Lee Nuclear Station Units 1 and 2

Evaluation of 2012 Field Investigation Results for Plant Relocation

FIGURE 30

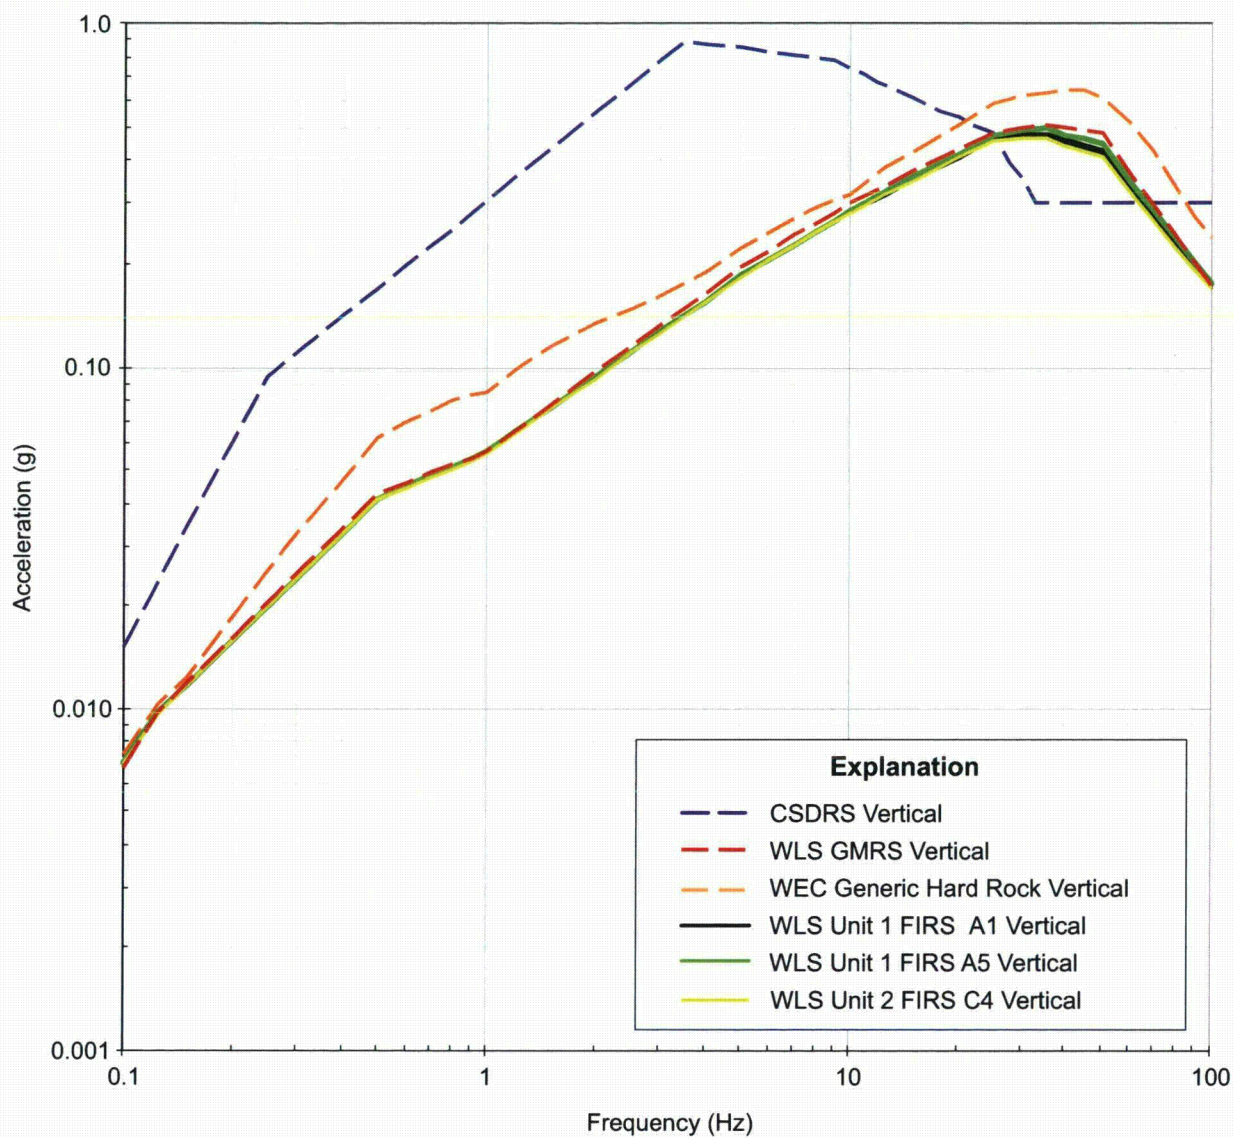
As shown on Figure 30, the horizontal GMRS and Unit 1 FIRS (revised FSAR Figure 3.7.1-201) exceed the horizontal CSDRS at frequencies of about 20 to 75 hertz and 20 to 85 hertz, respectively. PGA at 100 hertz of the GMRS and Unit 1 FIRS is 0.21 g and 0.23 g, respectively. As shown on Figure 31, the vertical GMRS and Unit 1 FIRS (revised FSAR Figure 3.7.1-202) exceed the vertical CSDRS at frequencies between about 25 to 70 hertz. There is no change to the conclusion expressed in the FSAR Revision 6 that the WLS site provides uniform hard-rock support for the nuclear island, and the site characteristic GMRS and Unit 1 FIRS are less than the horizontal and vertical WEC generic hard rock spectrum at all frequencies. The site complies explicitly with the AP1000 DCD and no site-specific analysis is required.

FIGURE 2.5.1-220

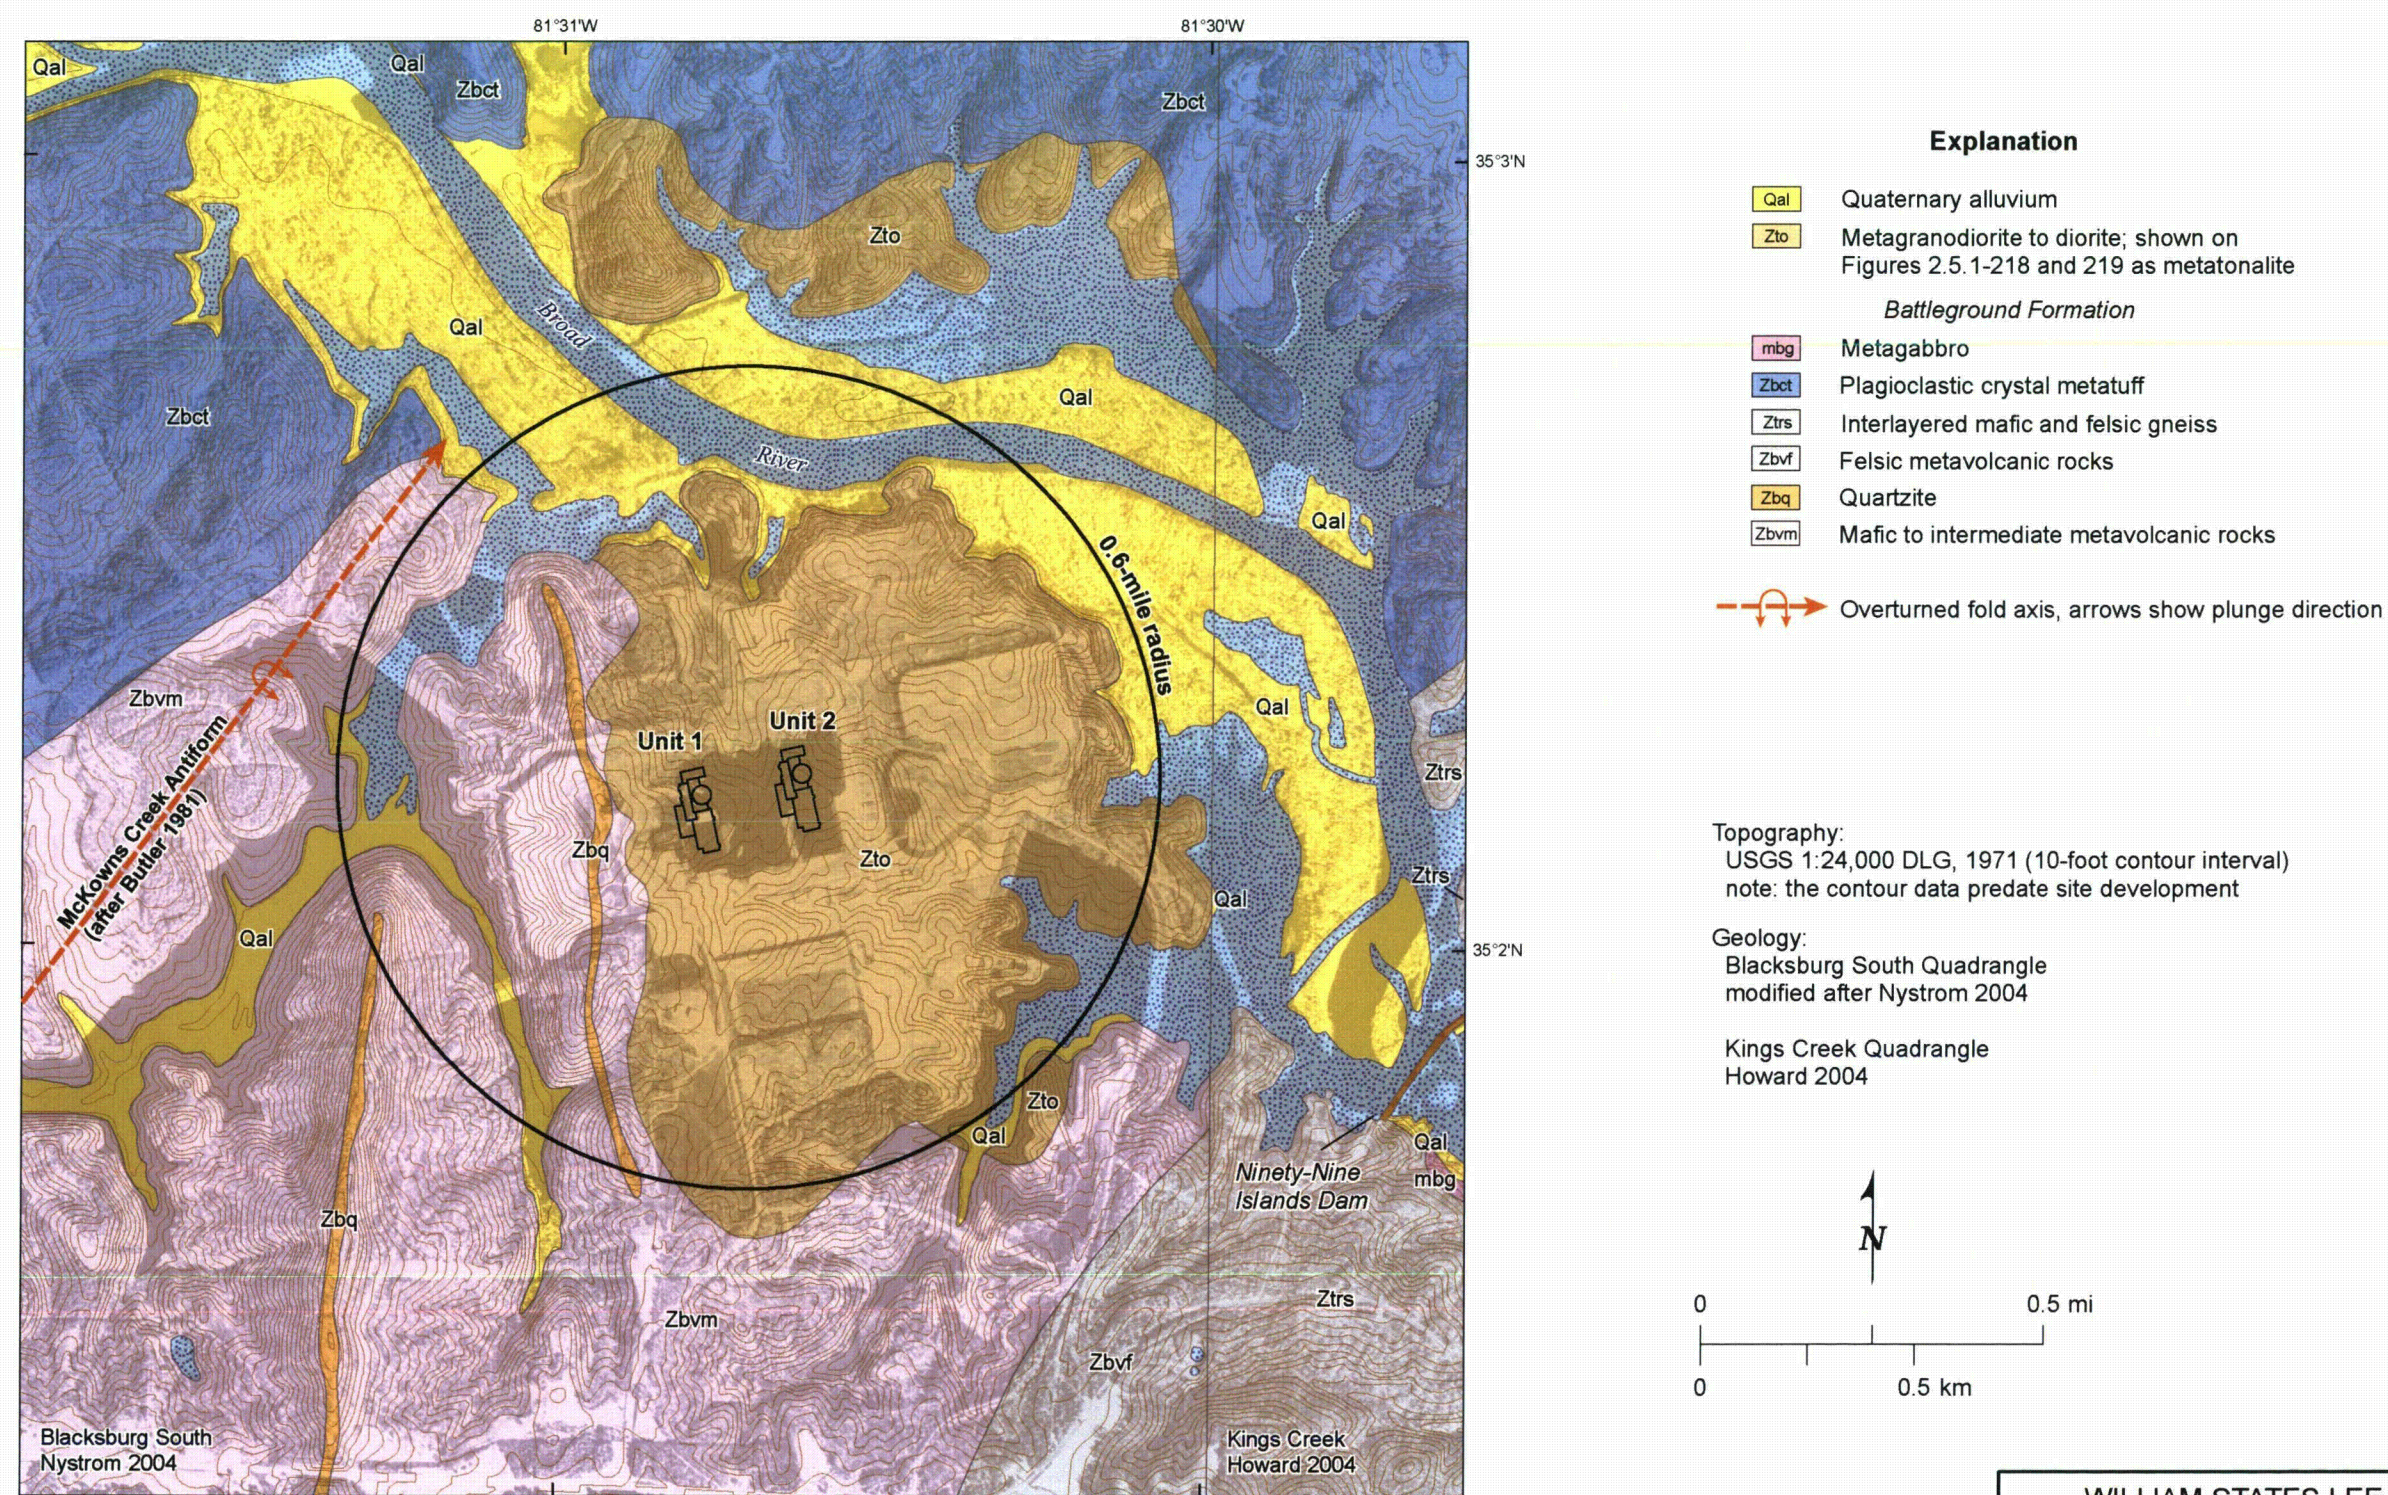
The locations of the Lee Nuclear Station on FSAR Figures 2.5.1-220, Site Geologic Map, and 2.5.1-229, Surficial Geologic Map of Existing Excavation will be revised to depict the relocated plant location. Evaluations of regional and site geologic and seismic information described in this subsection remain valid. No updates or changes to conclusions presented in FSAR Subsection 2.5.1 Revision 6 are planned as a result of plant relocation.

1. COLA Part 2, FSAR Chapter 2, Figure 2.5.2-220 is revised as follows:

- FSAR Figures 2.5.1-220, Site Geologic Map, and 2.5.1-229, Surficial Geologic Map of Existing Excavation will be revised to illustrate the relocated Lee Nuclear Station.

FIGURE 2.5.1-229

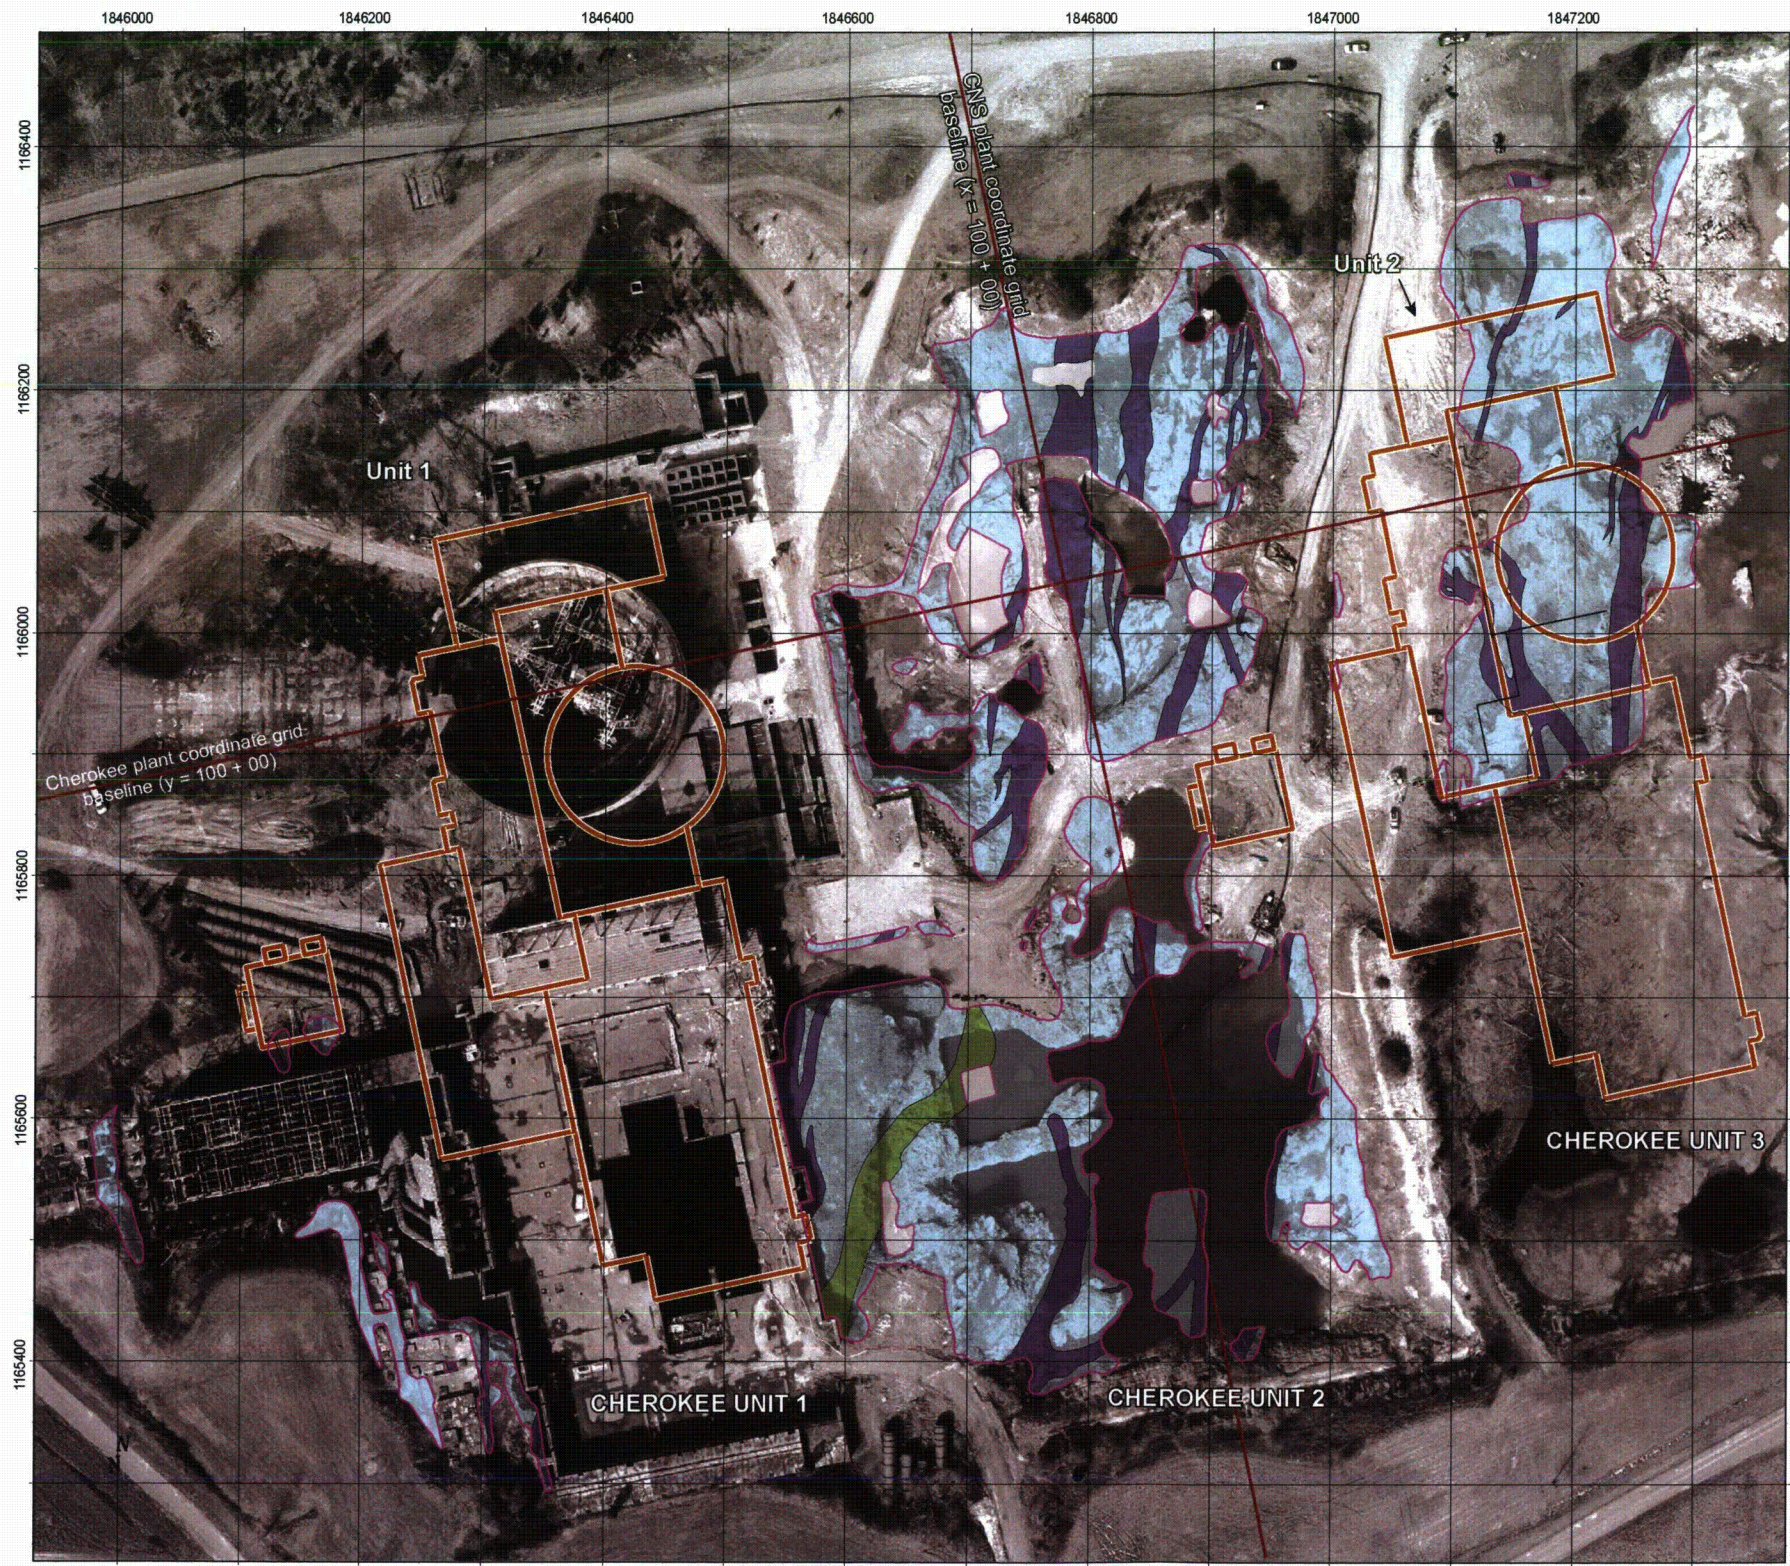
2. COLA Part 2, FSAR Chapter 2, Figure 2.5.1-229 is revised as follows:
